# Access Compliance Report

## Public Rights-of-Way

### (Curb Ramps)

Intersection ID: 9794	Main Street: N_GARDNER_AV	Cross Street: W_TRADE_ST	Location:	E
ADA ID: D710DB3A49FA	Ramp Type: PerpDiag	Initial Pass/Fail: Fail	Overall Compliance: No	Severity Score: 12.5
Codes/Mitigation Info/Possible Solution		Field Measurements/Component Compliance

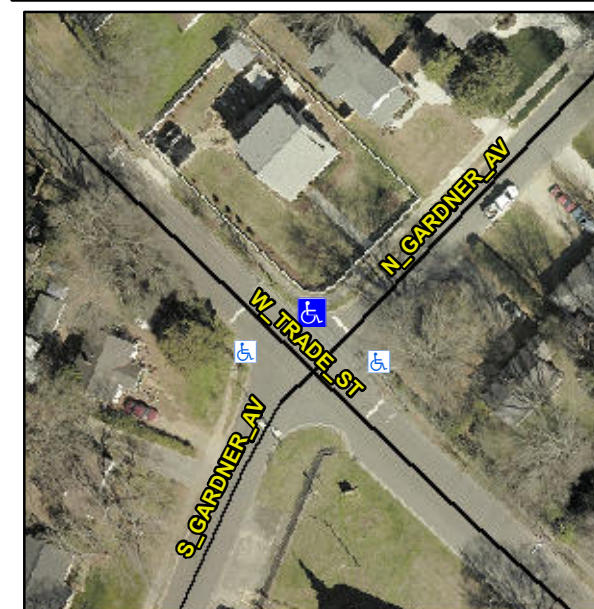
**Not Found, R304.5.3**

Compliance	Description	Data	Compliance	Description	Data
N/A	Ramp Length (in)	51.0	Yes	Ramp Slope (%)	7.8
Yes	Ramp Width (in)	48.5	No	Ramp XSlope (%)	5.1
N/A	Flare Type LT	N/A	N/A	Flare Type RT	N/A
N/A	Flare Slope LT (%)	N/A	N/A	Flare Slope RT (%)	N/A
N/A	Flare Traversable LT?	N/A	N/A	Flare Traversable RT?	N/A
N/A	Landing Length (in)	N/A	N/A	DWS Provided?	N/A
N/A	Landing Width (in)	N/A	N/A	DWS Contrast?	N/A
N/A	Landing Slope (%)	N/A	N/A	DWS Length (in)	N/A
N/A	Landing X Slope (%)	N/A	N/A	DWS Full Width?	N/A
N/A	Landing Curb? (Y/N)	N/A	N/A	DWS Offset (in)	N/A
N/A	Shared Landing?	N/A			
N/A	Gutter Ponding?	N/A	N/A	Gutter Slope (%)	N/A
N/A	Gutter Lip Ht (in)	0.5	N/A	Gutter X Slope (%)	N/A
N/A	Painted X Walk1?	No	N/A	Painted X Walk2?	No
	X Walk 1 Direction	To SW		X Walk 2 Direction	To SE
N/A	X Walk 1 Width (in)	N/A	N/A	X Walk 2 Width (in)	N/A
	X Walk 1 Slope (%)	1.6		X Walk 2 Slope (%)	4.6
	X Walk 1 X Slope (%)	5.4		X Walk 2 X Slope (%)	0.3

**Remove & Replace Curb Ramp With Two New Directional Ramps or Equivalent.**
